IEEE P802.11

Wireless Access Method and Physical Layer Specification

D2.0 Changes Referenced in Michael Fischer's Letter Ballot Response

Michael Fischer
 Digital Ocean, Inc.
 4242-3 Medical Drive
 San Antonio, TX 78229

Figure 4-11: DATA Frame

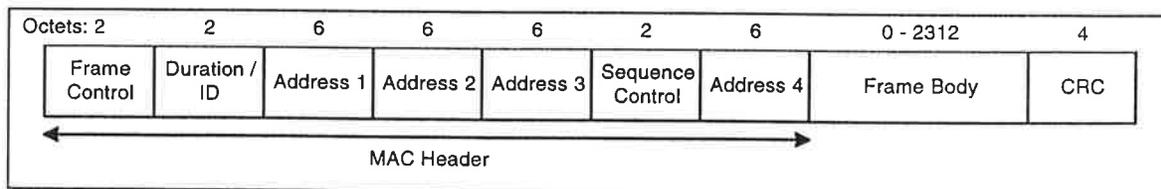
{modifications to clause 4.2.2.1}

The frame format for a Data frame is independent of subtype and shall be as defined in Figure 4-11.

The contents of the Address fields of the Data frame shall be dependent upon the values of the To DS and From DS bits and are defined in table 4-4, below. Where the content of a field is shown as N/A, the field shall be omitted.

Figure 4-xx. Encapsulated Information Element Format and Values for Type 2 Ethernet

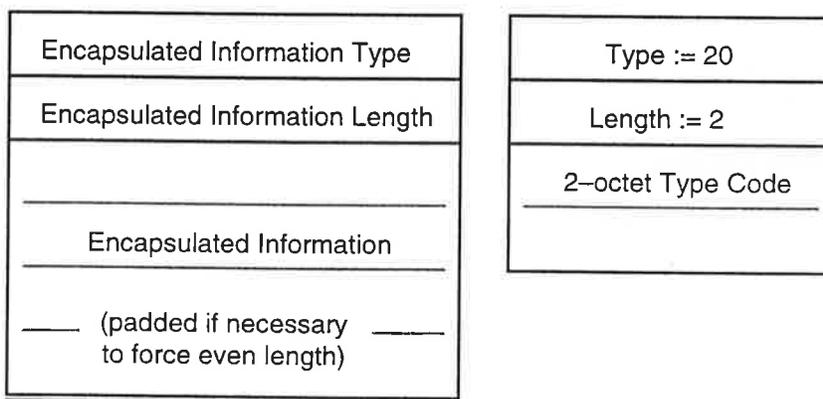
{insert a new clause, 4.3.2.7, immediately following 4.3.2.6}

The general format of the encapsulated information element, and the specific layout and values for use with type 2 Ethernet, are shown below in Figure 4-xx. The first octet shall contain a type code indicating the type of encapsulated information. The type value of 20 shall indicate a protocol type code. All other type values are reserved. The second octet shall indicate the element length, as the number of octets in the remainder of the element. The element length shall always be an even number. If necessary, a pad octet shall be added at the end of the encapsulated information to maintain even octet alignment for the remainder of the MSDU payload. For type value '20', the information length shall be '2'.

Figure 6-1: MAC Architecture Block Diagram

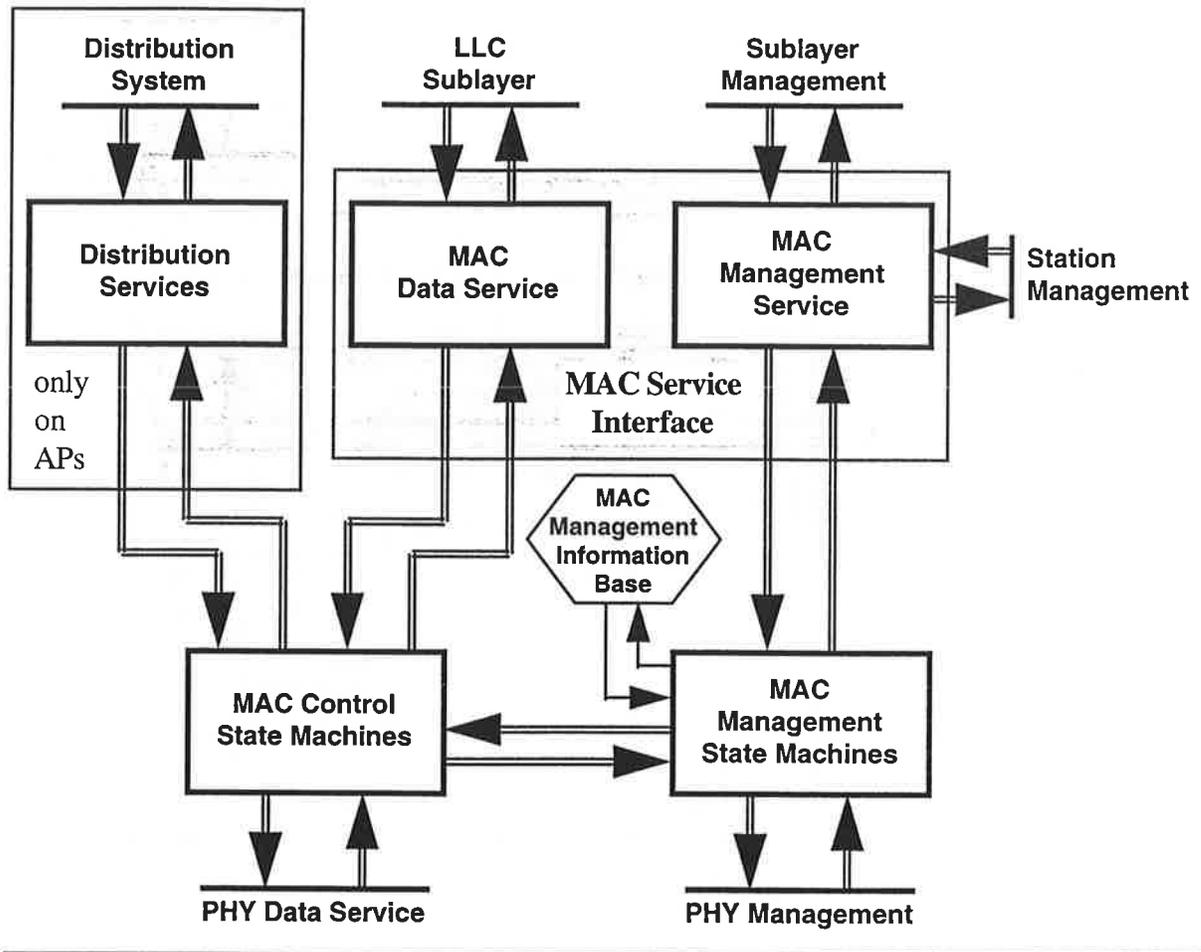
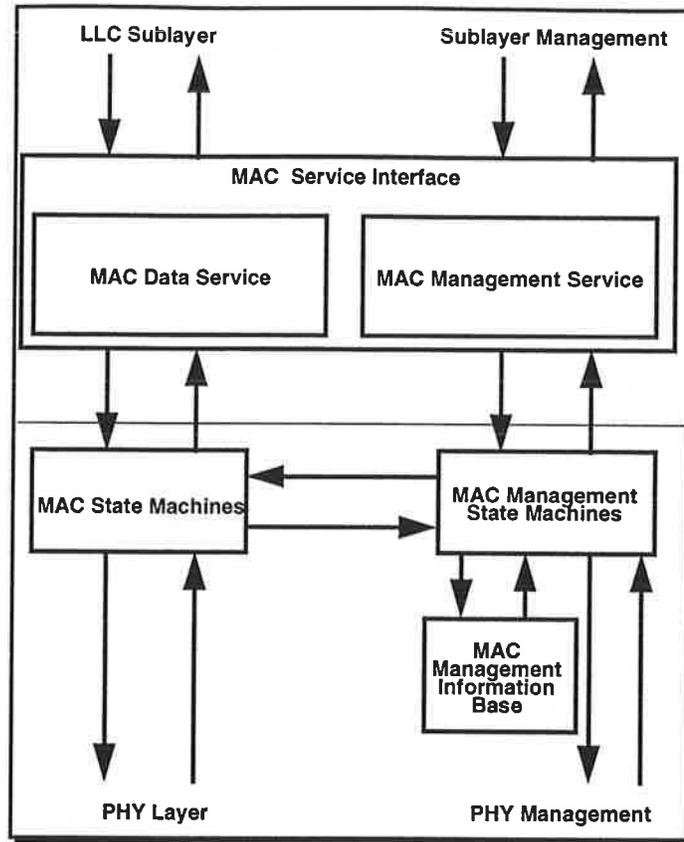
{modifications to clause 6.1}

The MAC is composed of several functional blocks: the MAC Data Service Interface (between MAC and -LLC)-Service Interface, the MAC Control State Machines, the MAC Management Service Interface (between MAC and sublayer or station management entities), the MAC Management State Machines and (at access points) the Distribution Services Interface (between MAC and the distribution system). The MAC Management Information Base (MIB) is maintained by the MAC Management function. The MAC-LLC Service Interface comprises the MAC Data Service and the MAC Management Service. These blocks perform the functions required to provide higher layer access to contention and contention-free frame transfers-access control on a variety of physical layers. These frame transfer functions are provided without reliance upon particular data rates or physical layer characteristics. The MAC provides both distributed and point coordination functions and is able to support both asynchronous and connection-based services. Under certain circumstances, the connection-based services in conjunction with the point coordination function may be able to provide a time bounded service classeselases. Figure 6-1 illustrates the MAC architecture.

Figure 6-2: Alternative view of MAC architecture.

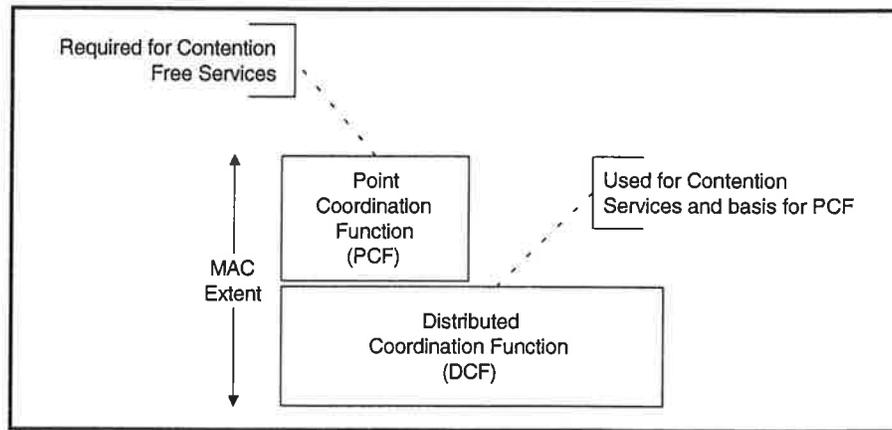
Viewed along a different axis, the MAC architecture can be described as shown in Figure 6-2 below as providing the point coordination function through the services of the distributed coordination function.

Figure 6-3: Fragmentation

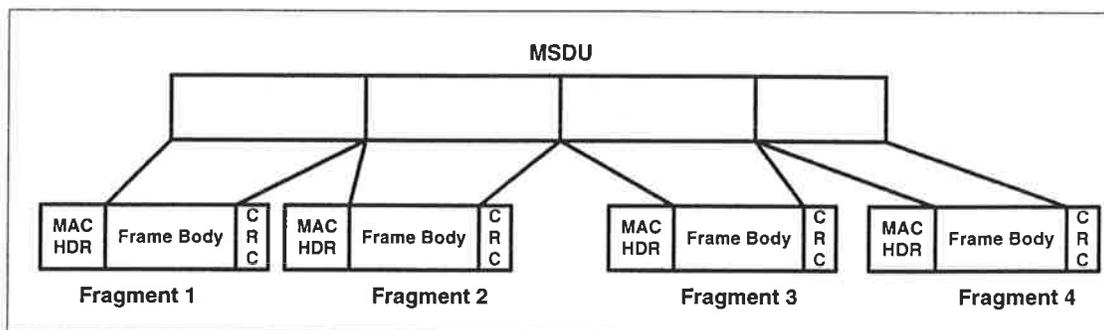
{modifications to clause 6.1.4}

When a frame is received from the LLC with a MSDU size greater than a Fragmentation_Threshold, the frame must be fragmented. The MSDU is divided into MPDUs. Each MPDU is a fragment with a frame body no larger than a Fragmentation_Threshold. It is possible that the final fragment may contain a frame body smaller than a Fragmentation_Threshold Payload. An illustration of fragmentation is shown in Figure 6-3.

Figure 6-14: CFP / CP Alternation

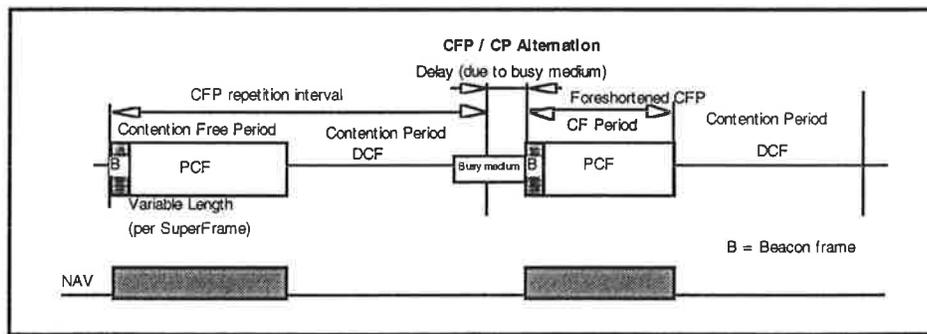
{modifications to clause 6.3.1}

The PCF controls frame transfers during a Contention Free Period (CFP). The CFP alternates with a Contention Period (CP), when the DCF controls frame ~~transfers, as~~ ~~transfers,~~ as shown in Figure 6-14. Each CFP begins with a Beacon frame that contains a DTIM Element (hereafter referred to as a ~~“DTIM”~~ ~~“DTIM”~~). The CFPs occur at a defined repetition rate, which is synchronized with the beacon interval as specified below.

Figure 6-15: Beacons & Contention Free Periods

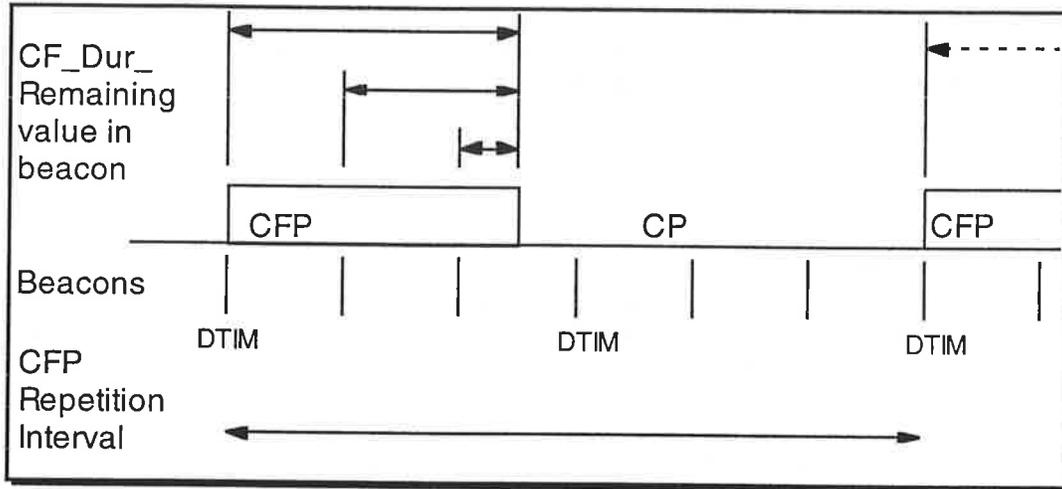
The length of the CFP is controlled by the PC, with maximum duration specified by the value of the aCFP_Max_Duration attribute in the MAC MIB ~~managed object~~ at the PC. Neither the maximum duration nor the actual duration (~~signaled~~ ~~signalled~~ by transmission of a control frame of Subtype CF-End or CF-End+Ack ~~frame~~ by the PC) are

constrained to be a multiple of the beacon interval. If the CFP-Rate is greater than the beacon interval, the PC shall transmit beacons at the appropriate times during the CFP (subject to delay due to traffic at the nominal times, as with all beacons). The PCF Parameter Set Element in all beacons at the start of, or within, a CFP contain a non-zero value in the CFP_Dur_Remaining field. This value, in units of ~~microseconds~~ ~~milliseconds~~, specifies the maximum time from the transmission of this beacon to the end of this CFP. The value of the CFP_Dur_Remaining field is zero in beacons sent during the contention period. An example of these relationships is illustrated in figure 6-15, which shows a case where the CFP-Rate is 2 DTIM intervals, the DTIM interval is 3 beacon intervals, and the aCFP_Max_Duration value is approximately 2.5 beacon intervals.

Figure 6-16: Example of Delayed Beacon and Foreshortened CFP

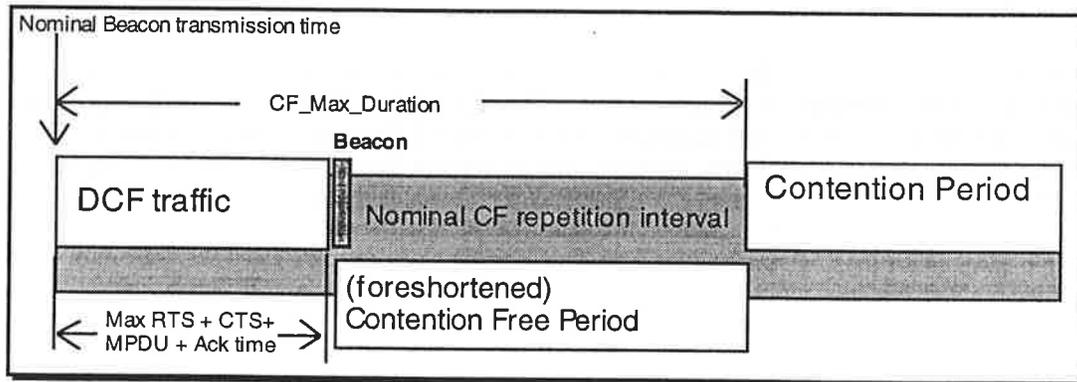
The PC may terminate any CFP at or before the CFP_Max_Duration, based on available traffic and size of the polling list. Because the transmission of any beacon may be delayed due to a medium busy condition at the ~~TBTT_{nominal}~~ ~~beacon transmission time~~, a CFP may be foreshortened by the amount of the ~~beacon transmission~~ delay. In the case of a busy medium due to DCF traffic, the upper bound on this delay is the maximum RTS + CTS + max_MPDU + Ack duration. In cases where the beacon transmission is delayed, the CFP_Dur_Remaining value in the beacon at the beginning of the CFP shall specify a time that causes the CFP to end no later than the ~~TBTT_{nominal}~~ ~~beacon transmission time~~ plus the value of aCFP_Max_Duration. This is illustrated in figure 6-16.

Figure 6-17: Example of PCF Frame Transfer

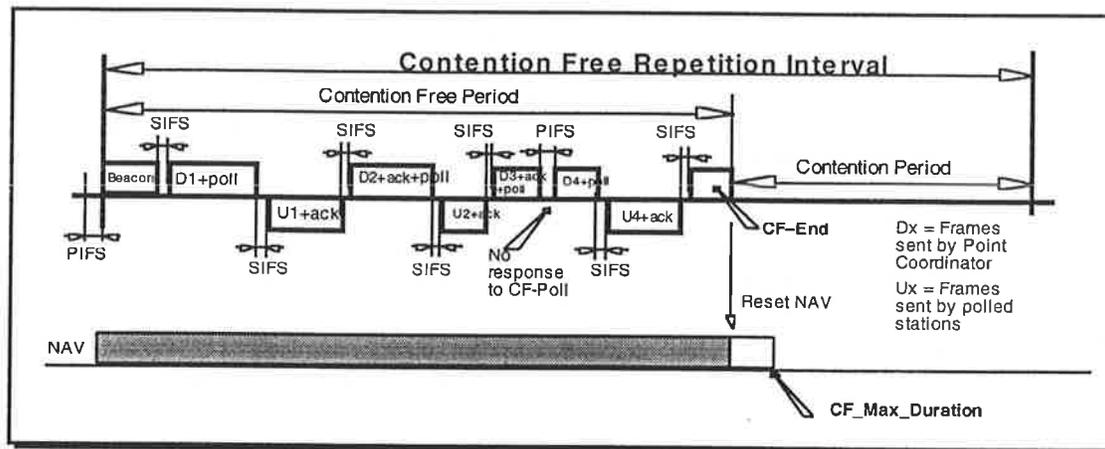
{modifications to clause 6.3.3}

Frame transfers under the PCF typically consists of alternating ~~between~~ frames sent from the AP/PC and frames sent to the AP/PC. During the CFP, the ordering of these transmissions, and the station allowed to transmit frames to the PC at any given point in time, is controlled by the PC. Figure 6-17 depicts a frame transfer during a typical CFP. The rules under which this frame transfer takes place are detailed in the following paragraphs.

Figure 6-18: Station-to-Station Contention Free Transfer

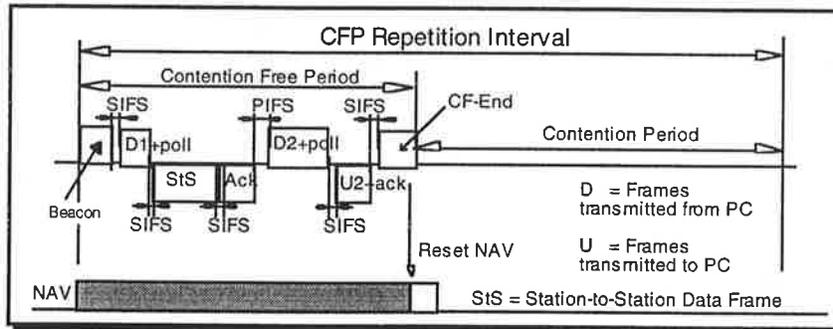
{modifications to clause 6.3.3.2}

A CF-Aware station, when transmitting in response to a CF-Poll (any type), may send a Data frame to any station in the BSS an SIFS gap after receiving the CF-Poll. If the addressed recipient of this transmission is not the AP, the Data frame is received and acknowledged according to the DCF rules for Data frames. However, RTS and CTS control frames are never used during the CFP, even if the frame size exceeds aRTS Threshold, because the NAV at all stations in the BSS is already set at least long enough to protect the data frame and its acknowledgment. This is illustrated in Figure 6-18. The PC may resume transmitting as soon as an SIFS gap after the Ack frame, if the PC hears the Ack, or a PIFS gap after the expected time for the ACKAck frame (the PC cannot resume after an SIFS gap because the station-to-station frame may be fragmented), if the PC does not hear the Ack.

Figure 6-19: Dynamic Polling List Update Technique

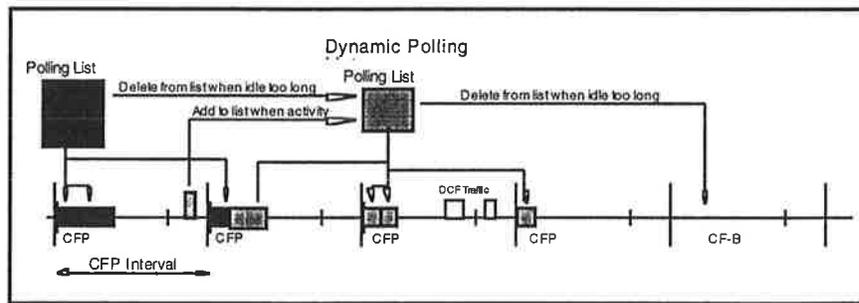
CF-Aware stations that are not on the polling list due to a static request during Association, and are not excluded from the polling list due to a static request during Association, may be dynamically placed on the polling list by the PC to handle bursts of frame transfer activity by that station. The PC may monitors CF-aware station activity during both the Contention Free period and the contention period. When a CF-aware station placed on the polling list dynamically has not transmitted a Data frame in response to the number of successive CF-Polls indicated in a Poll_Inactivity, then the PCF may delete that station from the polling list. When a CF-aware station not on the polling list, but not excluded from the polling list, has transmitted any Data frames during the previous contention period, then the PC may add that station to the polling list. This is illustrated in Figure 6-19.

Figure 8-4: Infrastructure Power Management Operation (No PCF Operating)

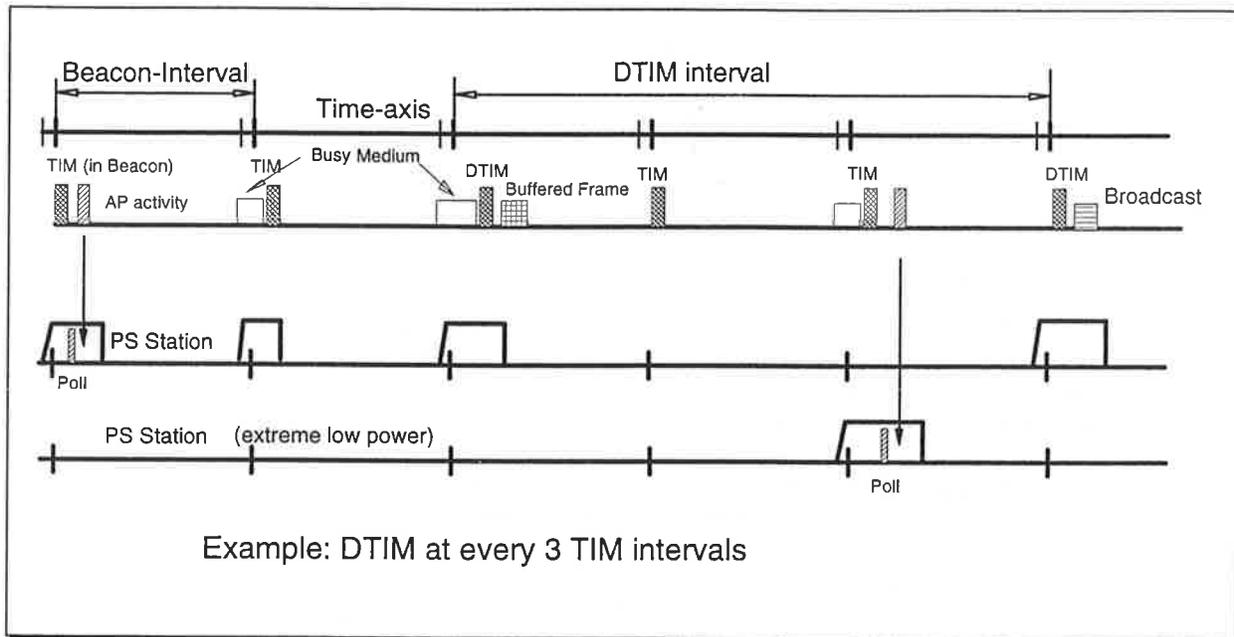
The following figure illustrates the AP and station activity under the assumption that a DTIM is transmitted once every three TIMs. The top line in the figure represents the time axis, with the Beacon Interval shown together with a DTIM Interval of three Beacon Intervals. The second line depicts AP activity. The AP schedules Beacons for transmission every Beacon Interval, but the Beacons may be delayed if there is traffic at the target beacon transmission times. This is indicated as "busy medium" on the second line. For the purposes of this figure, the important fact about Beacons is that they contain TIMs, some of which may be DTIMs.

The third and fourth lines in the figure depict the activity of two stations operating with different power management requirements. Both stations power on their receivers whenever they need to listen for a TIM. This is indicated in the figure as a ramp-up of the receiver power prior to the target beacon transmission time. The first station, for example, powers up its receiver and receives a TIM in the first beacon which indicates the presence of a buffered frame for it. It generates a subsequent PS-Poll frame, which elicits the transmission of the buffered Data frame from the AP. Broadcast frames are sent by the AP subsequent to the transmission of a Beacon containing a DTIM.
